ADDENDUM NUMBER 3

Project Number _____ Federal SRTS-INF-H284(105); City 89060340

Project Title _____ NE 48th Street Sidewalk – Safe Routes to School

ISSUE DATE: July 12, 2013

"C" - HANDRAIL DETAIL
NOT TO SCALE

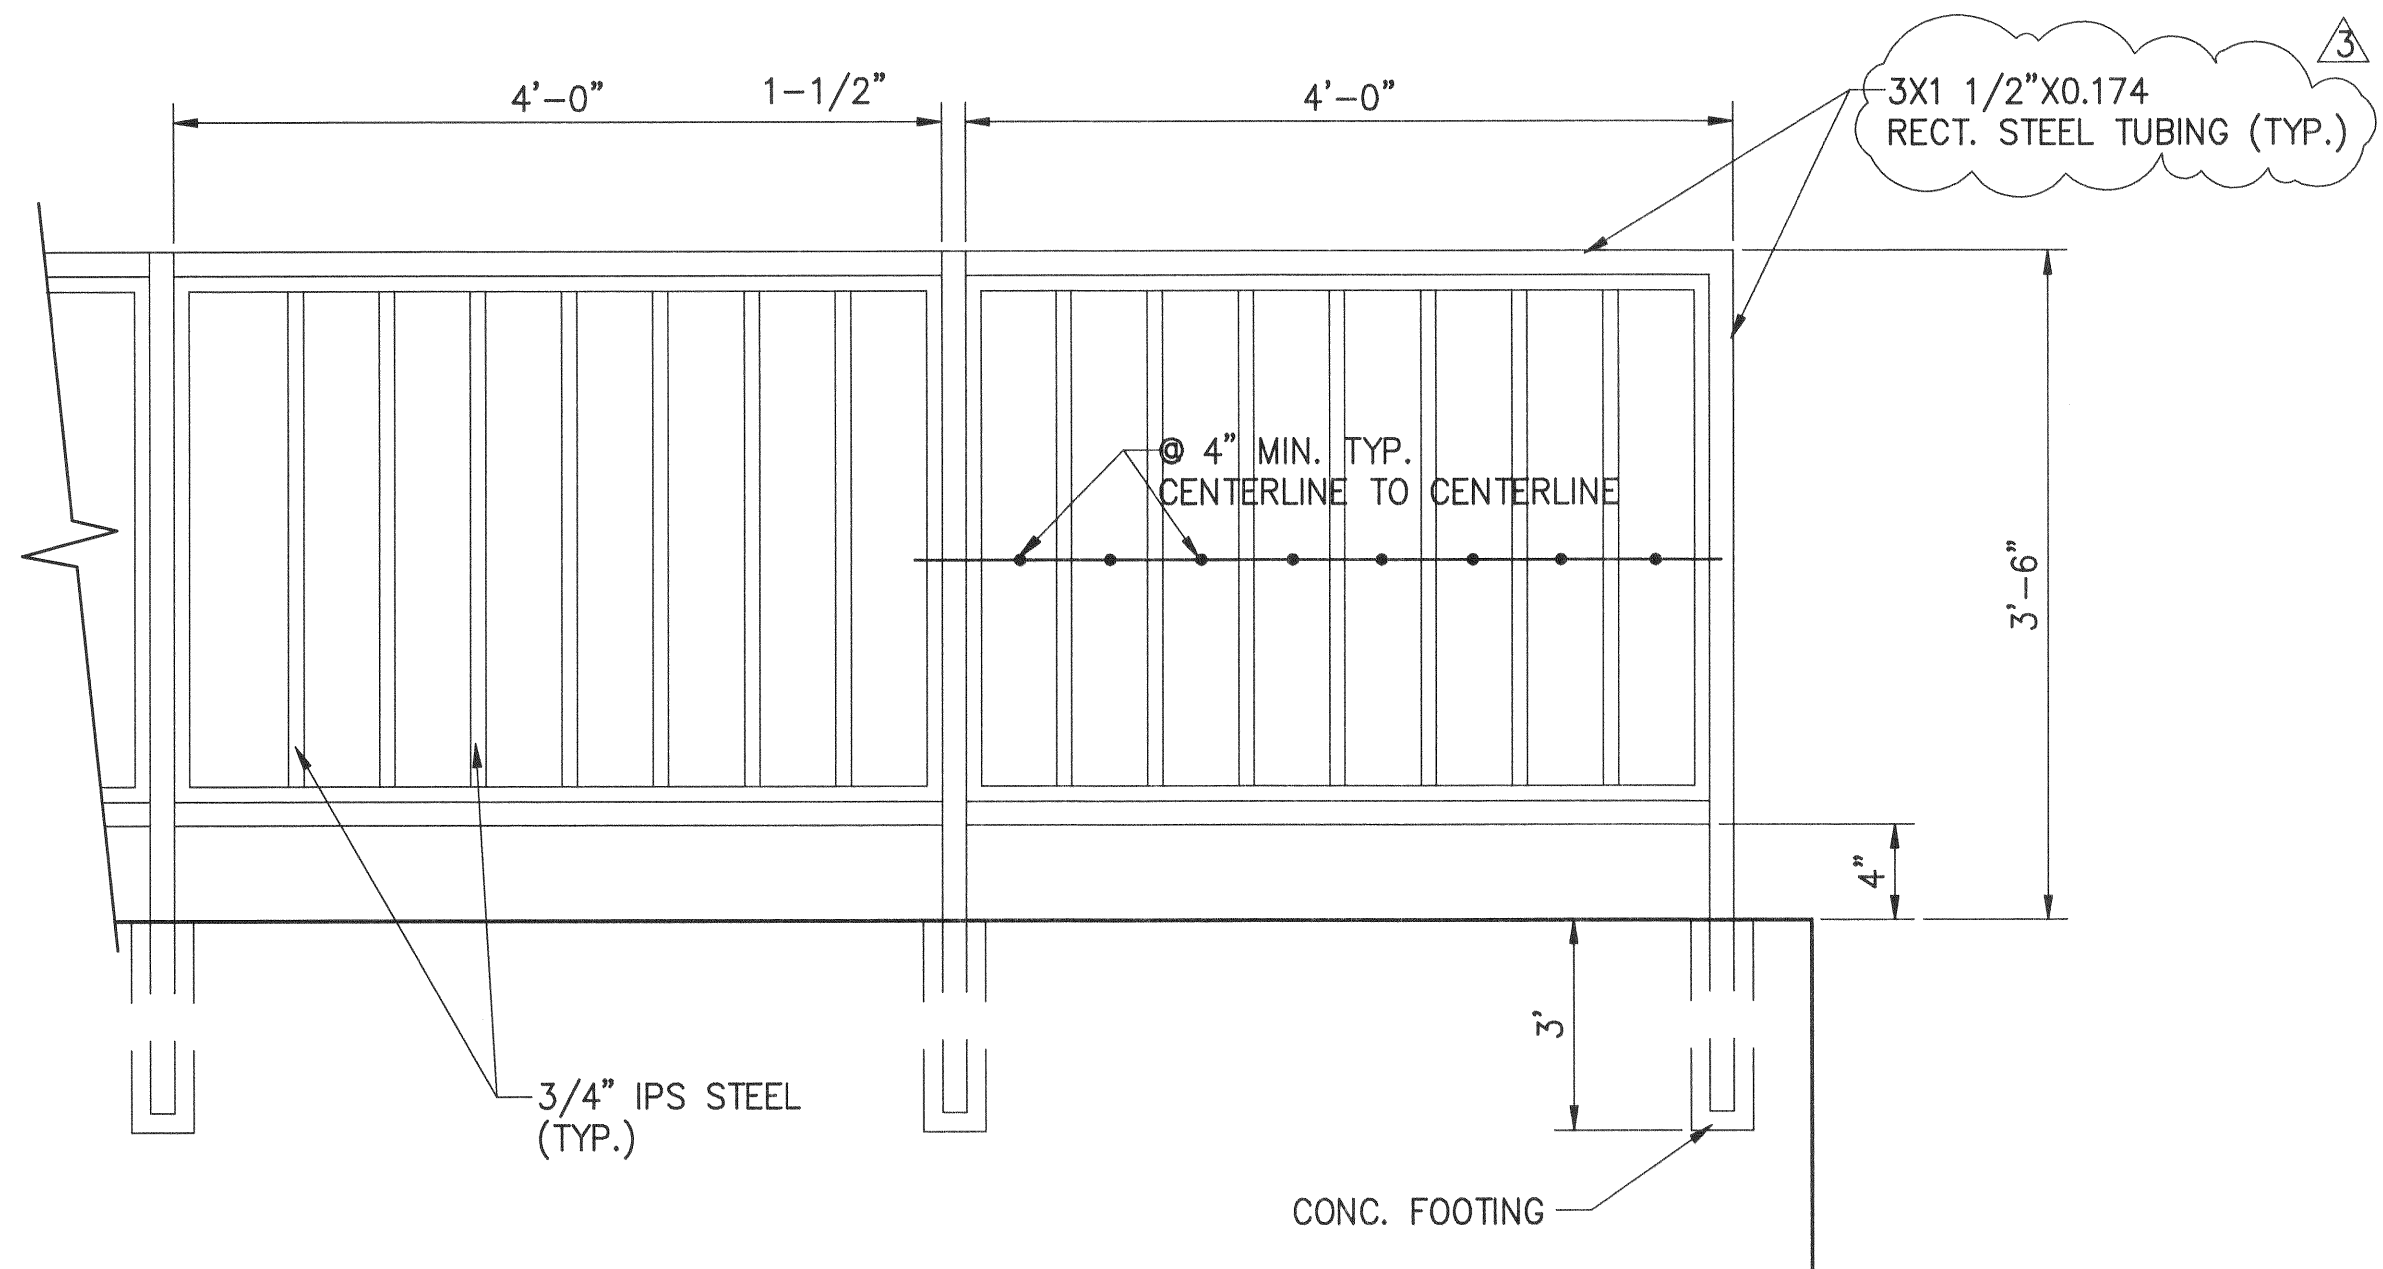
Answer: The salvaged existing top soil on site can be used for construction.
3. The specs for the hand rail call for the hand rail to be galvanized. The plans call for the rail to be painted. Which is it? Is it both?

Answer: The hand rail needs to be galvanized but not painted.
4. Traffic control note on sheet 18 allows for work only on one block at a time. This would be typical of downtown settings. Would this be appropriate in this setting?
